BECHTEL COMMENT

PURGE AND VENT VALVE OPERABILITY

QUALIFICATION ANALYSIS

BOSTON EDISON COMPANY
PILGRIM STATION # 600, UNIT 1

FIGURE 2 - 8" VALVE ASSEMBLY AND MATERIAL

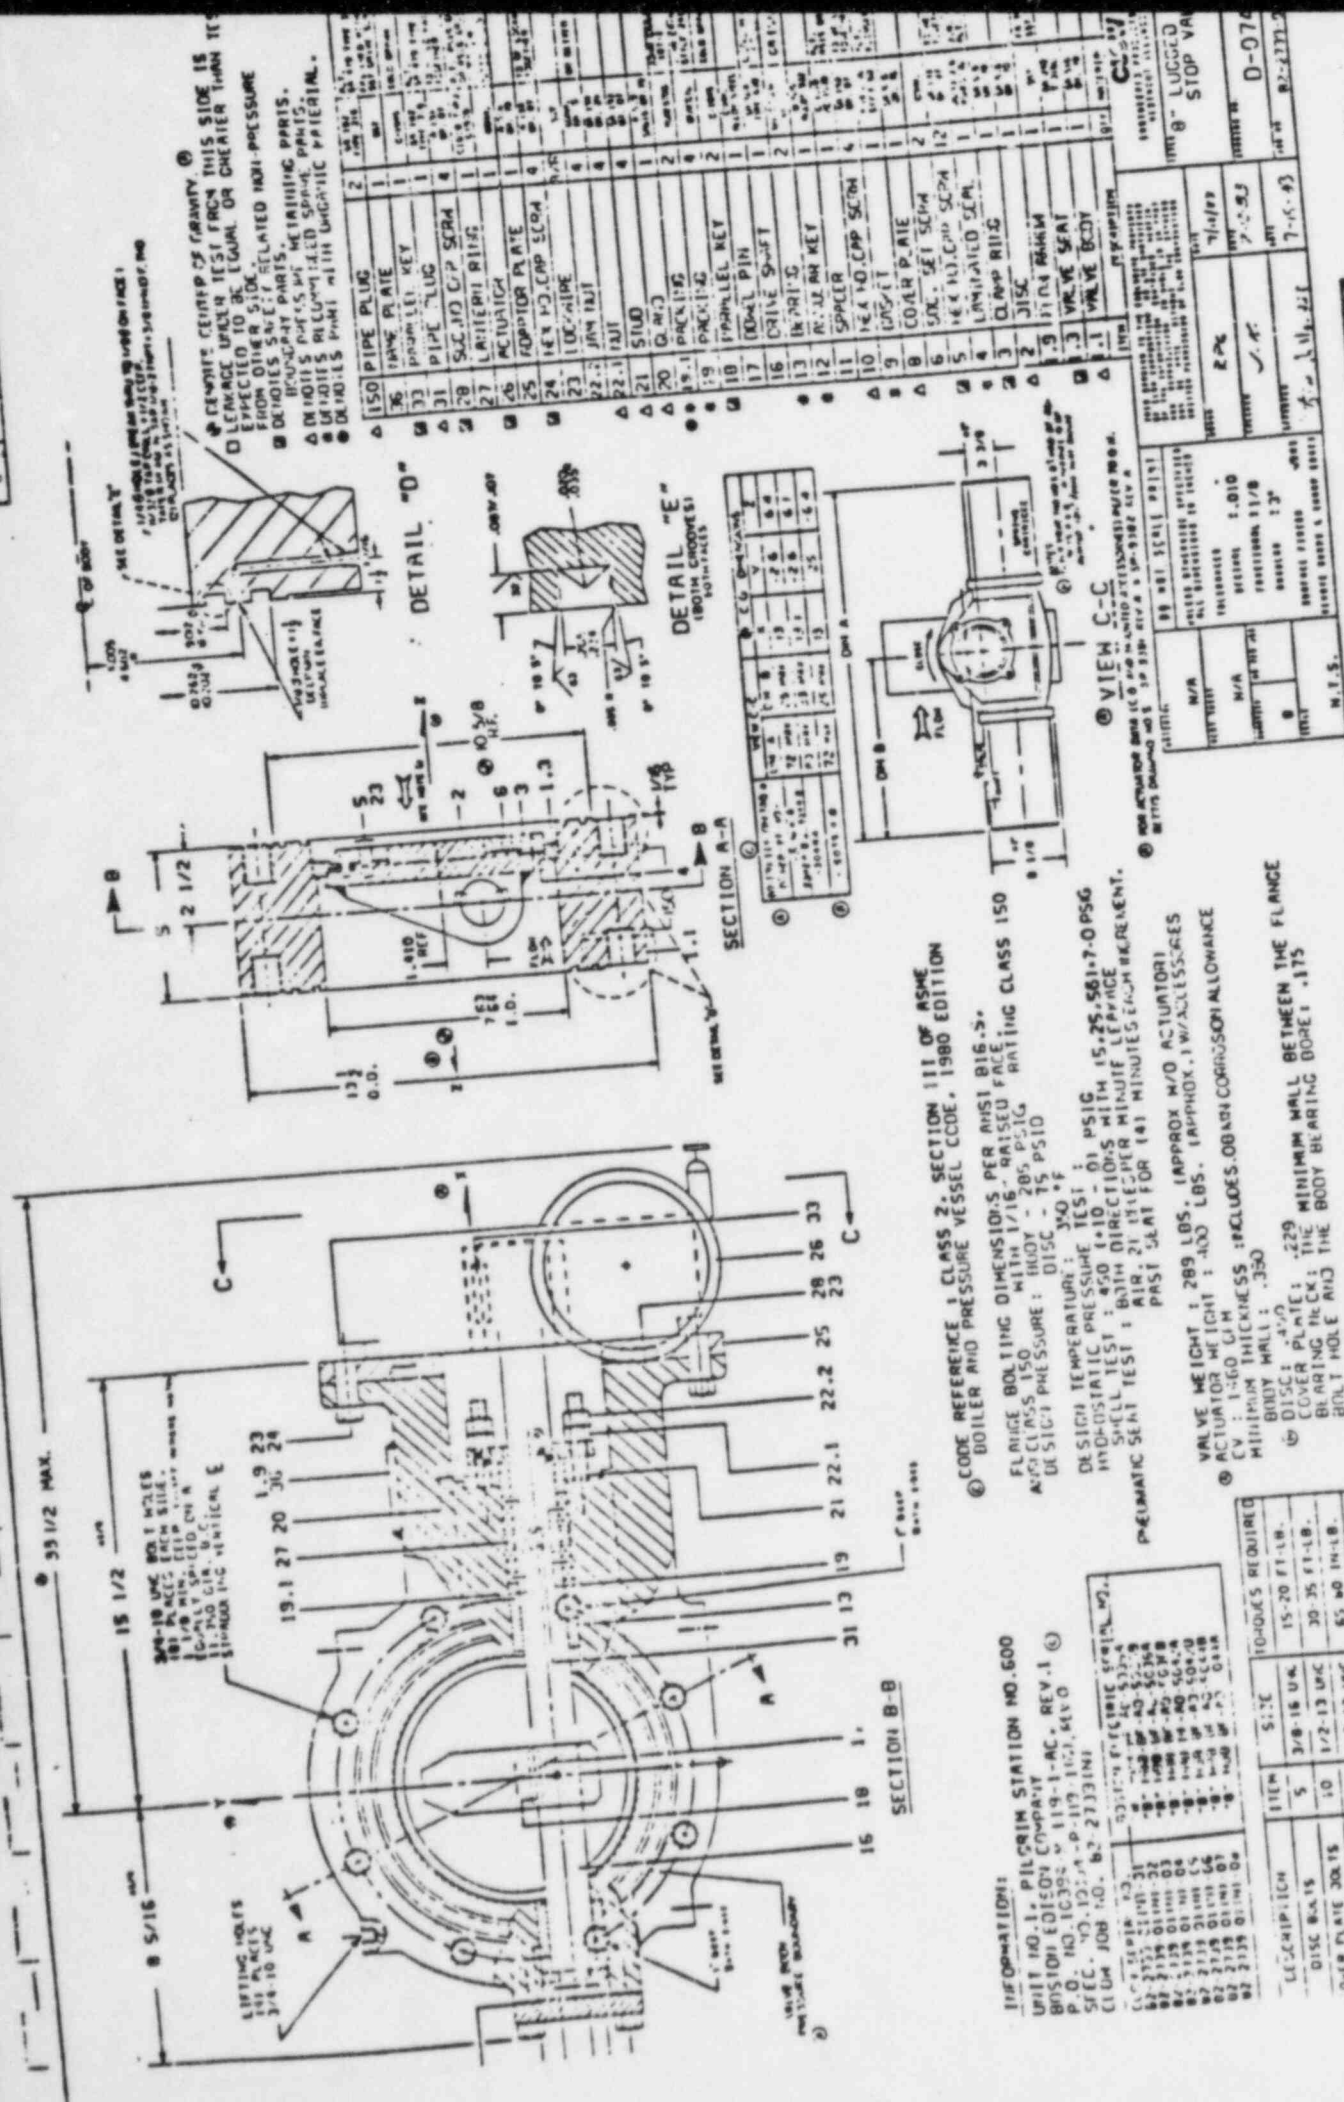
- V-A (1)a The thickness per ANSI B16.34 is exclusive of the corrosion allowance of 0.080. The drawing shows a body wall of .380". The design report states actual wall = 1.44".

- V-A (2) The disc thickness specified on the drawing is .450 inclusive of corrosion allowance. The calculation shows .520". The difference between the two must be reconciled.

Reply: Care must be taken in the interpretation of just what these numbers on the drawing are. Drawing D-0741C states that the minimum thickness of the body wall with corrosion allowance is .380". This is only the minimum. Due to the nature of the design of the valve, the actual body wall on the machining drawing comes out to be, conservatively, 1.44". However, minimum body wall with corrosion allowance should be .390" and not .380". This was an error. The arrangement drawing will be changed accordingly.

Reply: The calculation does not show a thickness of .520". It shows a calculated thickness of .370". $.370" + \text{C.A.} = .450"$ which is reflected on the arrangement drawing. The disc is machined at .520" for conservatism. The report is correct.
